**GENOA CHARTER TOWNSHIP
PLANNING COMMISSION PUBLIC HEARING
JULY 8, 2024
MONDAY
6:30 P.M.
AGENDA**

Attention:	Amy Ruthig, Planning Director
Subject:	Timber Green – Condominium/PUD Amendment Review #2
Location:	West side of Chilson Road, north of E. Coon Lake Road
Zoning:	RPUD Residential Planned Unit Development

**Re: Timber Green Amendment 3
Site Plan Review No. 2**

JOB #	20-056	DRAWN DC	CHK: MB
SCALE	1"=60'	SHEET	5
DATE	5/16/2024

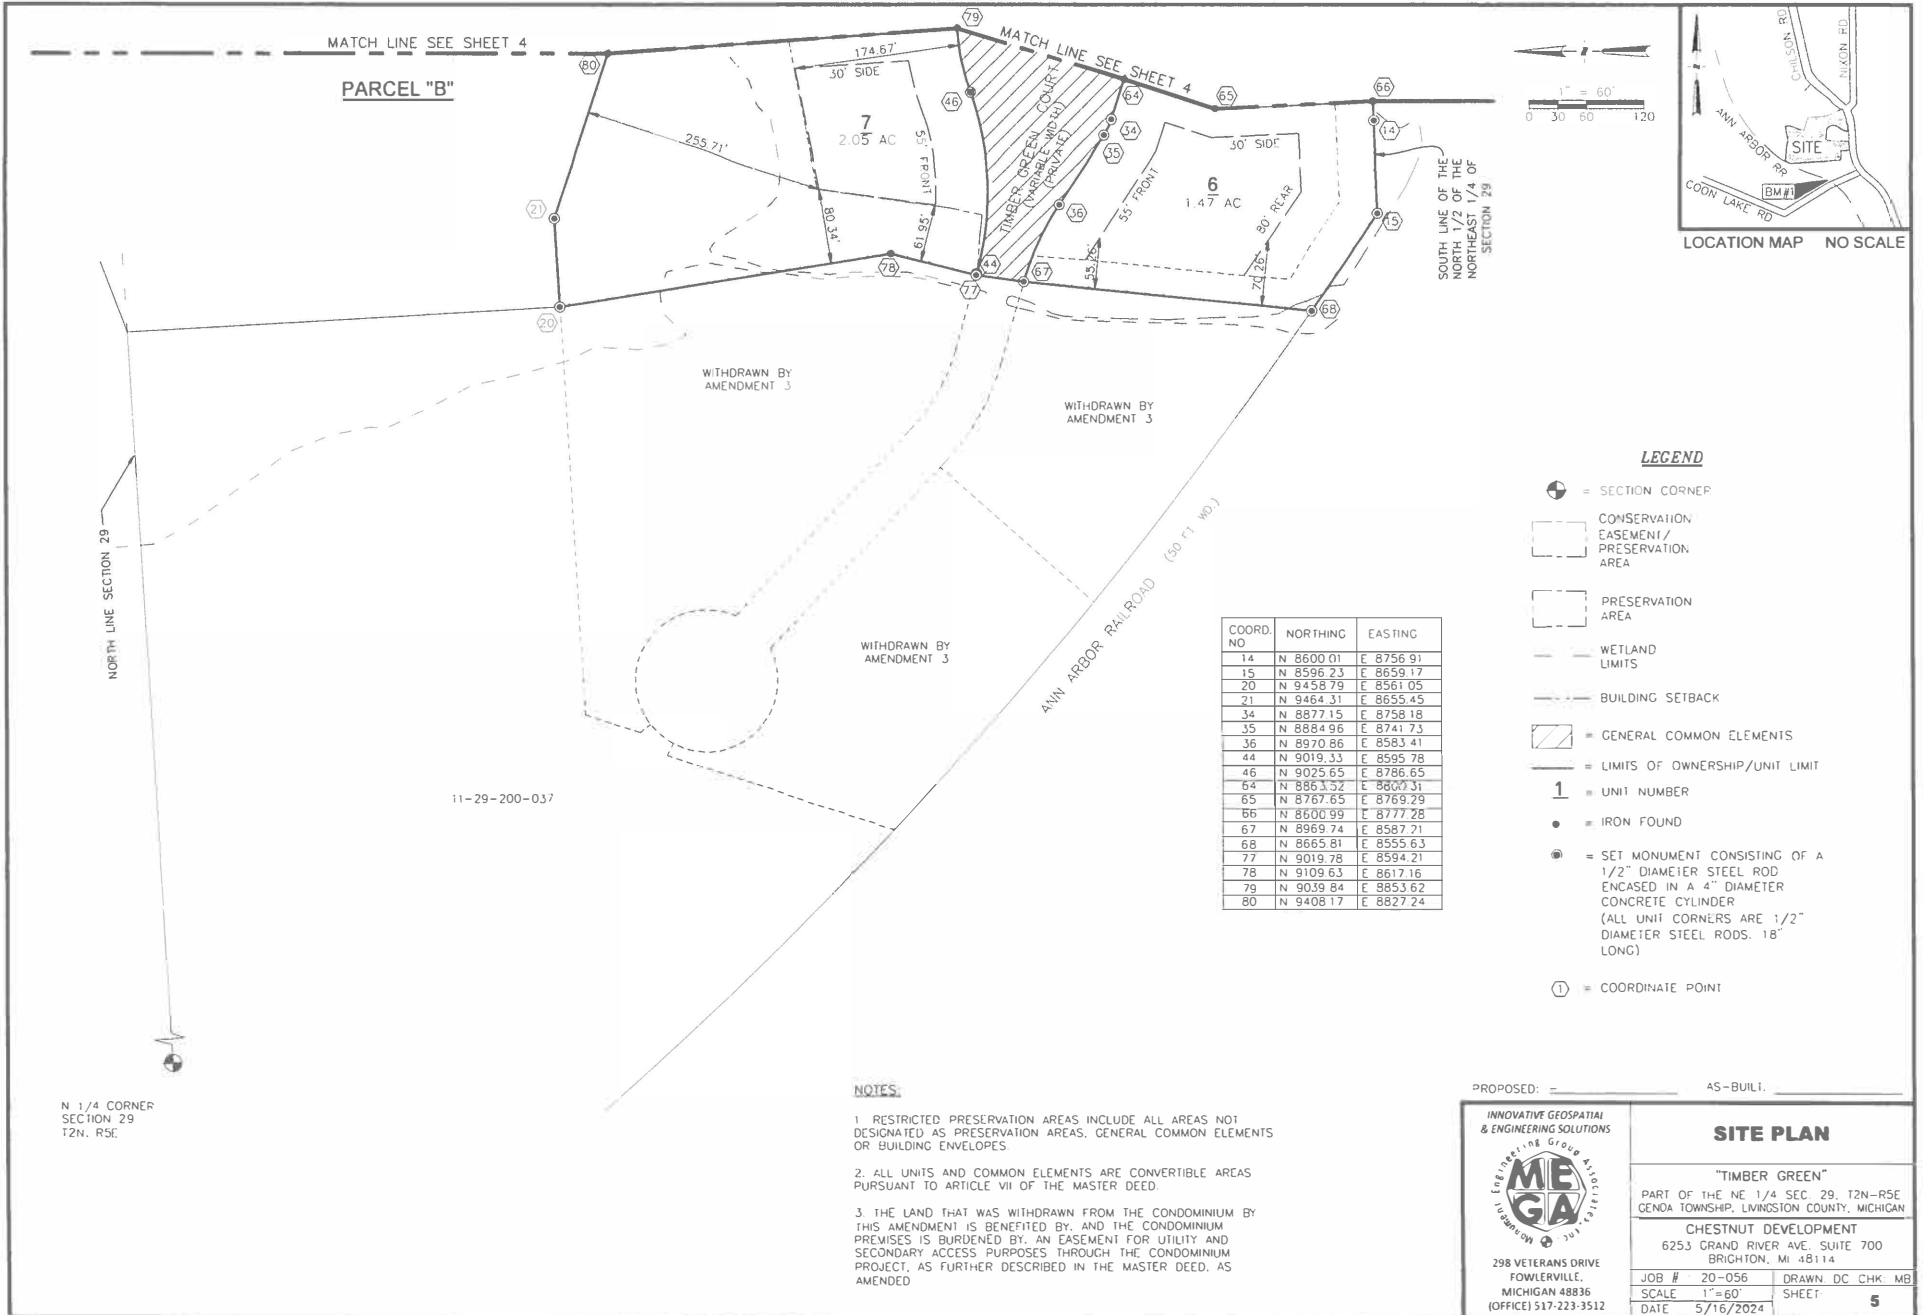
1. The applicant must address any comments provided by the Township Attorney or staff with respect to the amended Master Deed.
2. The applicant should provide documentation of the Association’s approval in writing.
3. Sheet 5 of Exhibit B does not depict the entirety of Parcel #11-29-200-037.
4. The applicant must address any comments provided by the Township Engineer or Brighton Area Fire Authority.
5. The Fire Authority may wish to require a gate and sign at the terminus of Timber Green Court since it will only be for secondary emergency access to the withdrawal property.

Additionally, an updated Exhibit B is included with the revised submittal; however, Sheet 5 of the Exhibit does not depict Parcel #11-29-200-037 in its entirety.
